Number	N.84
Section	Body
Page	1 of 2
Date	November, 1971.

BONNET MASCOT

Number	N.4
Section	Body and Exhaust System
Sheet	1 (of 1)
Date	May, 1960

PAINT COLOURS

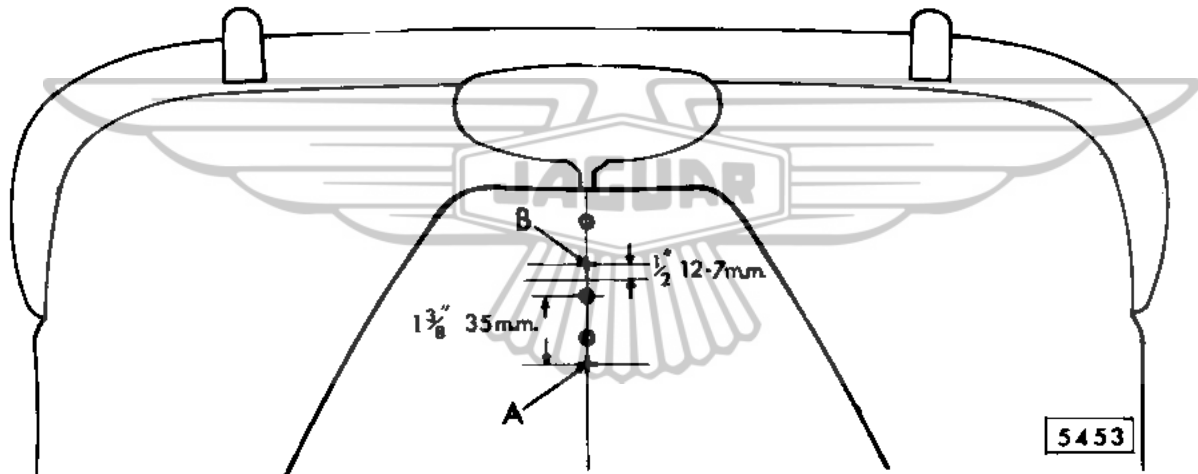
Difficulties in manufacturing Bonnet Mascot BD.10954 have resulted in it being withdrawn and supplies are no longer available. Orders for replacements for the above cars will therefore be executed by Jaguar Spares Division supplying an alternative Bonnet Mascot BD.29644 which varies from the original by the positions of the mounting studs. Instructions for the installation of the new Mascot are therefore detailed below.

If the original Bonnet Mascot, part number BD.10954, is replaced by Mascot part number BD.29644, the following instructions should be carefully followed:-

1. Remove original Mascot from bonnet
2. Remove front and rear portion of bonnet centre beading
3. Retouch paintwork (if necessary) where bonnet is affected by contact with Mascot or chrome beading.
4. Lightly mark centre line through existing fixing holes, extending line forward by 2 in. (50 mm.).
5. Drill 3/16 in. (4.8 mm.) hole 'A' on centre line, 1 3/8 in. (35 mm.) to rear of front Mascot fixing hole. Locate new Mascot in holes
6. Place rear chrome bead in position, mark against rear of new Mascot base. Remove chrome bead and carefully cut to length. Clean up end of bead.
7. Place front chrome bead in position, mark against front of new Mascot base. Remove chrome bead and carefully cut to length. Clean up end of bead.

8. Lightly mark bonnet across front of new Mascot base.
9. Remove Mascot and centre pop bonnet $\frac{1}{2}$ in. (12.7 mm.) forward of mark. Drill $\frac{1}{8}$ in. (3.17 mm.) diameter hole 'B' in bonnet.
10. Locate clip BD.11719 and secure to bonnet, using pop rivet BD.1814/6
11. Fit Mascot and secure to bonnet, using special cup washer, part number 1744 at front fixing, nuts UCN.119/2 and shake-proof washers C.723/A
12. Fit modified front and rear chrome beads.

BONNET LOCK - MODIFIED TYPE

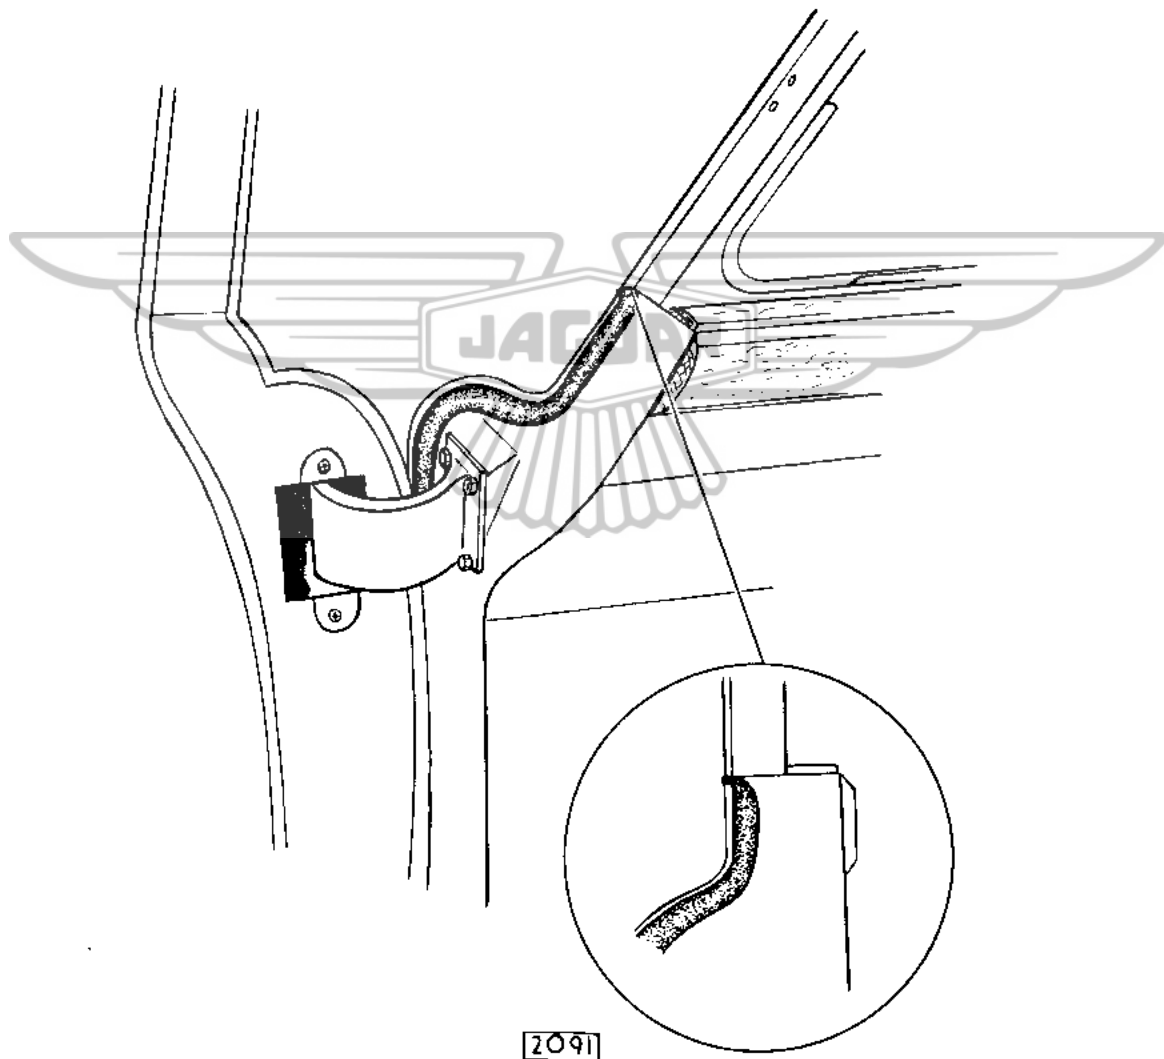
On cars with the above chassis numbers and onwards, a revised bonnet locking system is incorporated. The bonnet is fastened and released by means of two small levers one on either door hinge pillar.

To open the bonnet, turn the levers anti-clockwise and pull out to their full extent. Insert the fingers under the rear edge of the bonnet, press in the safety catch and raise the bonnet. To close the bonnet, push the bonnet closed, then applying pressure to the top of the bonnet, push the lever fully home and turn clockwise. Repeat for the other side of the bonnet. It is MOST IMPORTANT to ensure that the levers are out to their full extent and have not been pushed in accidentally before attempting to close the bonnet or the bonnet may be damaged.

SEAT BELT ATTACHMENT POINTS

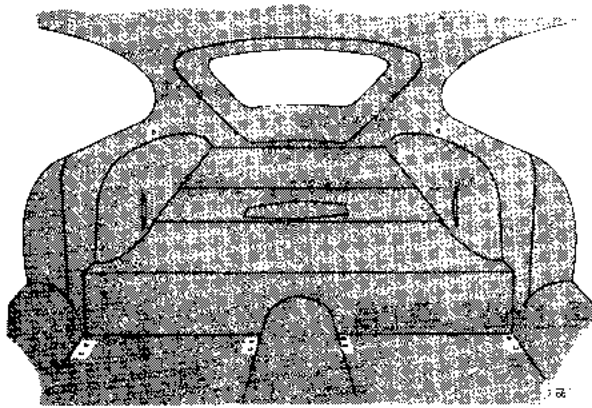
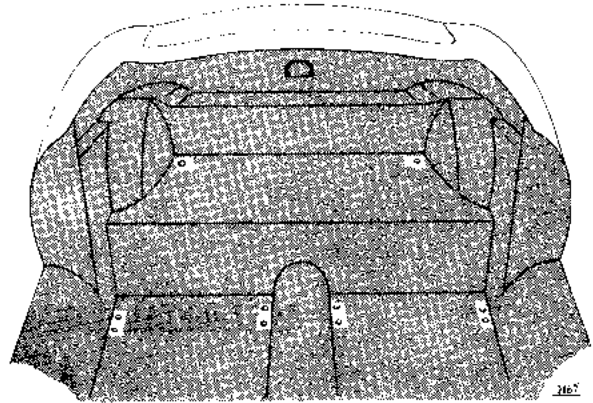
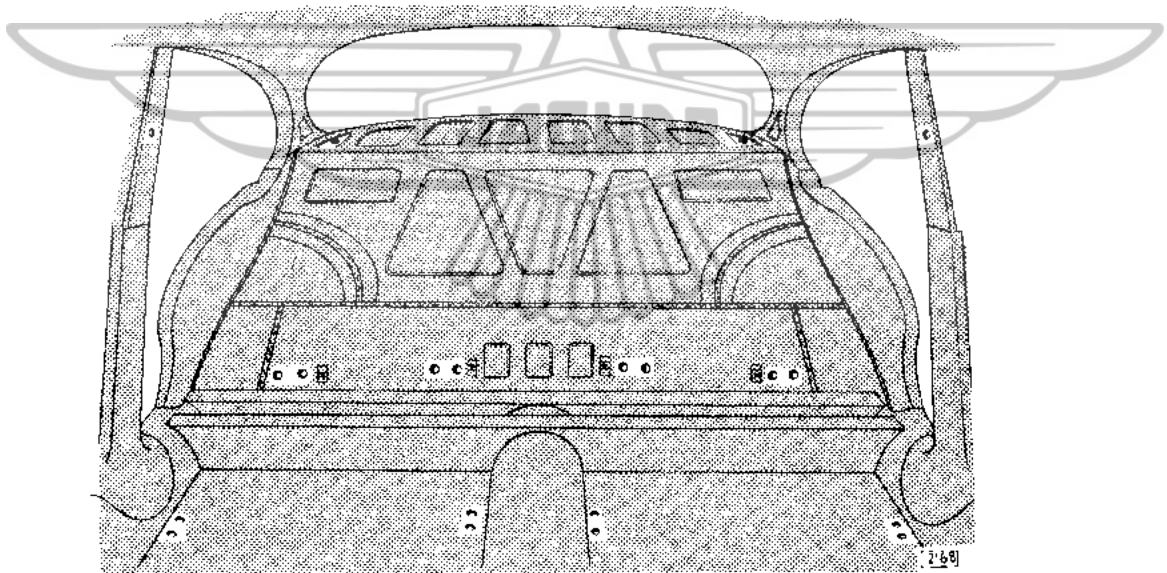
On cars with the above chassis numbers and onwards, mounting points for the attachment of seat belt anchor brackets are provided. The mounting points are in the positions shown overleaf and are designed to suit a wide range of seat belt types. The pairs of holes for floor mountings are $2\frac{1}{2}$ " (6.35 cm) between centres, one hole being a $\frac{3}{8}$ " (9.5 mm) plain clearance hole and the other being a $7/16$ " (11.1 mm) UNF tapped hole. The mountings holes behind the seats or on the centre pillars are all tapped $7/16$ " (11.1 mm) UNF. (See illustrations overleaf).

Owing to a typographical error, the diameter of the hole drilled in the luggage compartment floor was incorrectly stated as 5/16" (7.9 mm). This dimension should be altered both in the text and on the illustration to read 15/16"(23.8 mm).

JAGUAR SEAT BELTS.

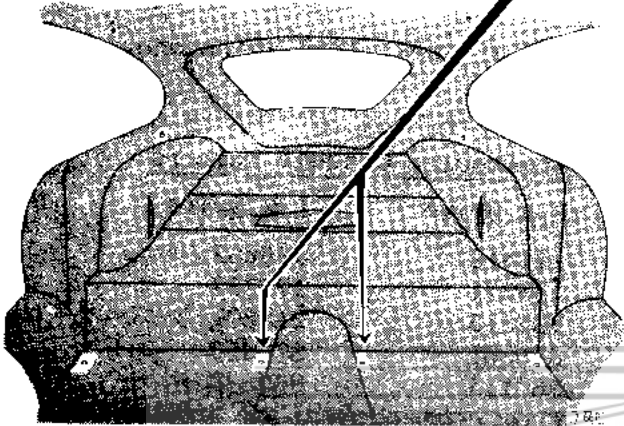
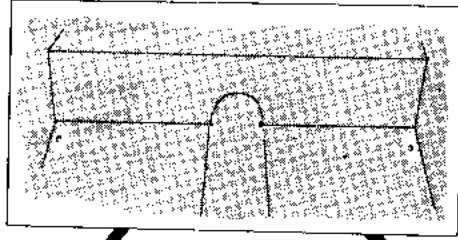
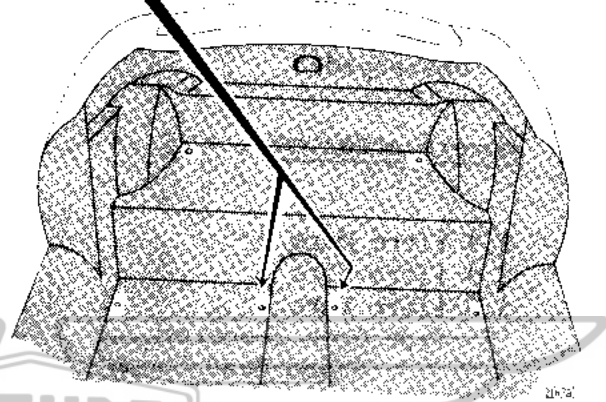
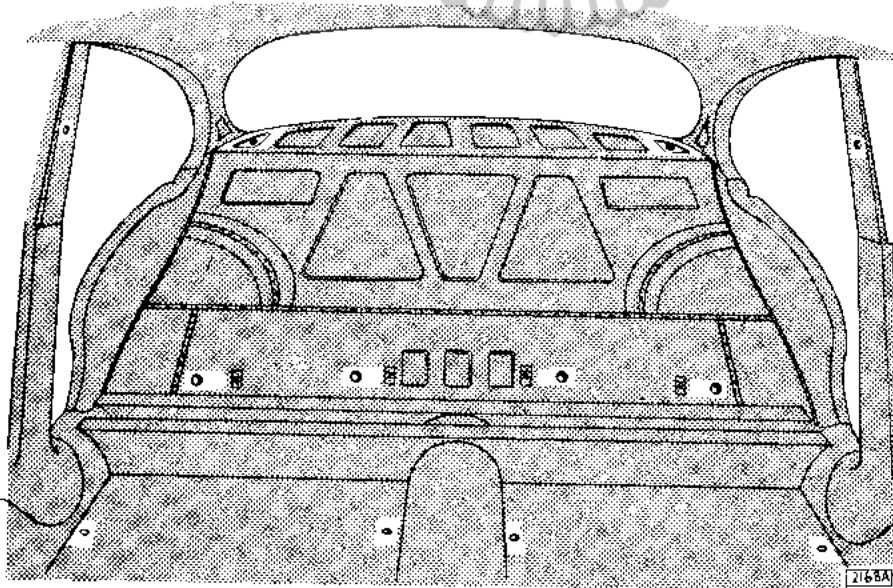
The positions of the anchorage points are shown overleaf. Earlier cars had two holes, one plain and one tapped, at the floor anchorage positions; later cars have only a single 7/16" (11.1 mm) U.N.F. tapped hole. In either case only the tapped holes will be used for anchorage purposes.

Note: The tapped holes in the floor are blanked off with plastic cross headed screws. On the Mark 2 and Mark 10 models, the tapped hole in each centre pillar is blanked off with a chrome plated escutcheon.

INSTRUCTIONS FOR FITTING RECLINING MECHANISM
TO SPECIAL ADAPTABLE TYPE FRONT SEATS.

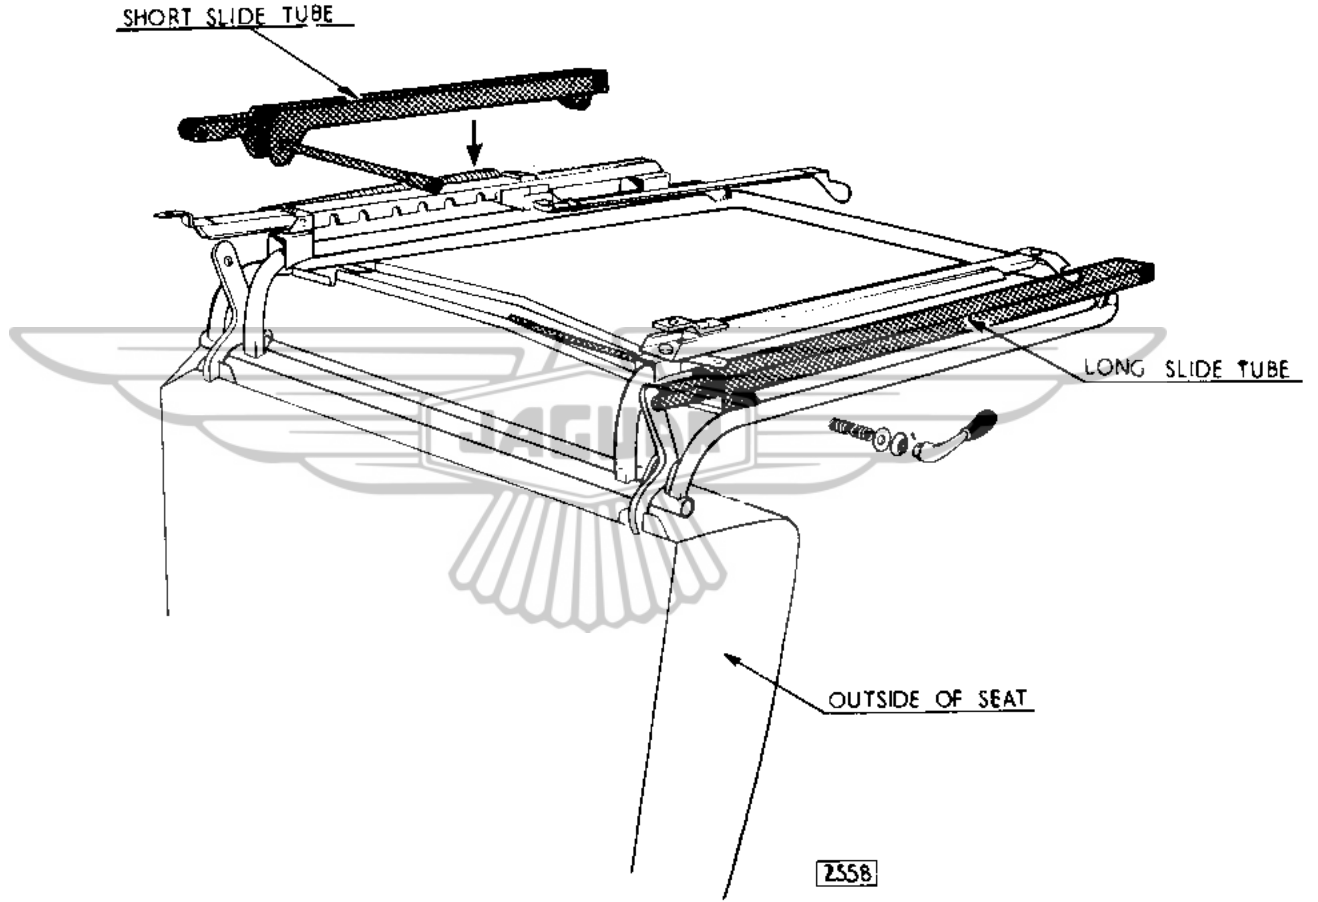
Remove the tie rods (2 per seat) locking the seat base to the squab, after extracting the setscrews, nuts and washers (see illustration).

Line up the lever with the holes in the bracket and insert the operating rod as shown in the illustration.

BOOT LID LOCK

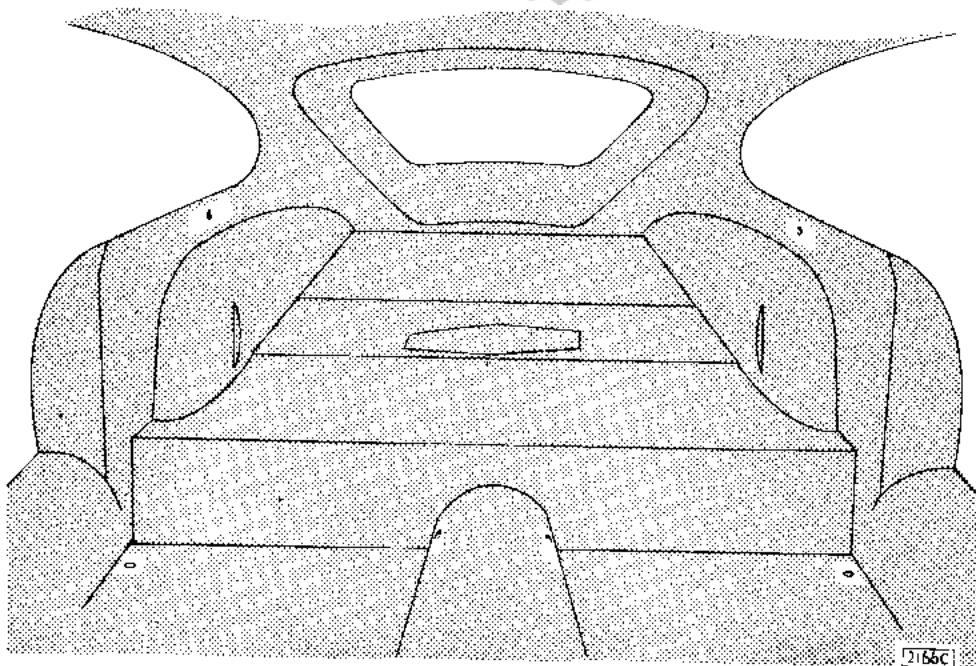
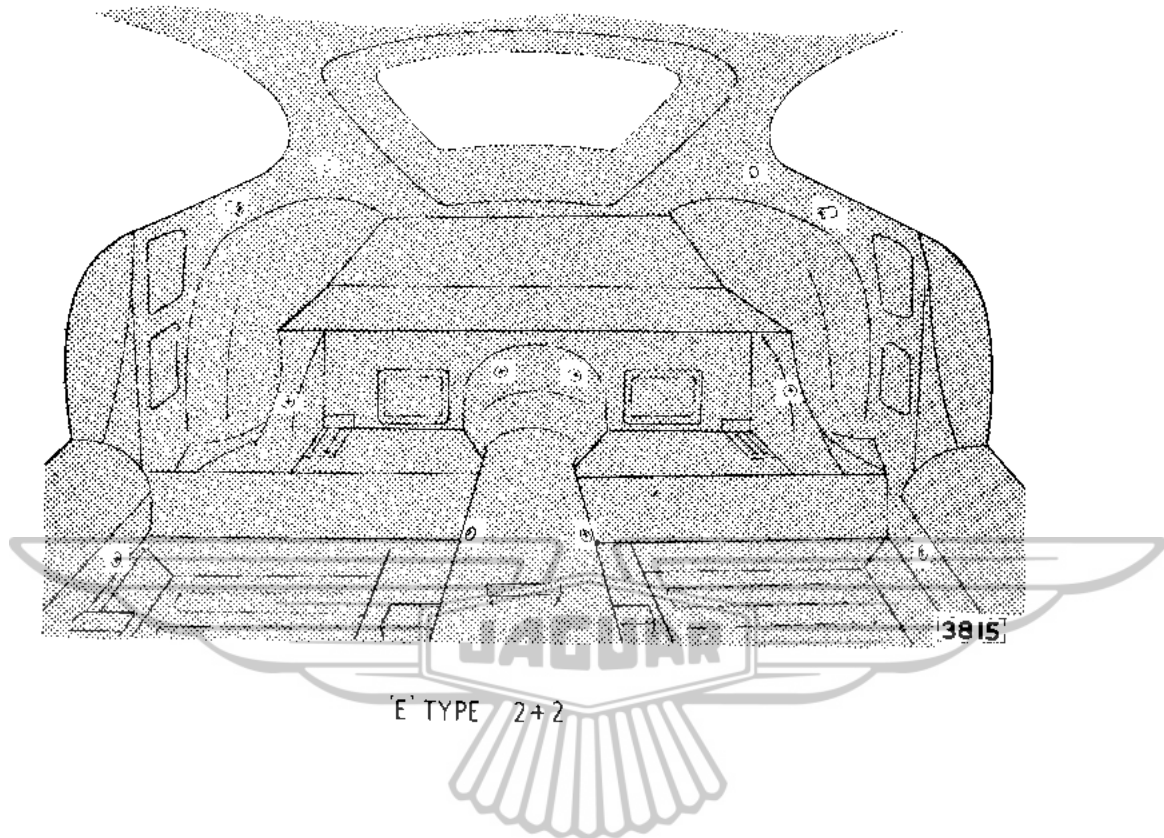
Commencing at the above chassis numbers an improved boot lid lock was fitted.

The lock incorporated a revised cam to prevent the boot lid from opening when on the road.

If complaints are received of the boot lid opening when the car is on the road, it is recommended that the new lock is fitted.
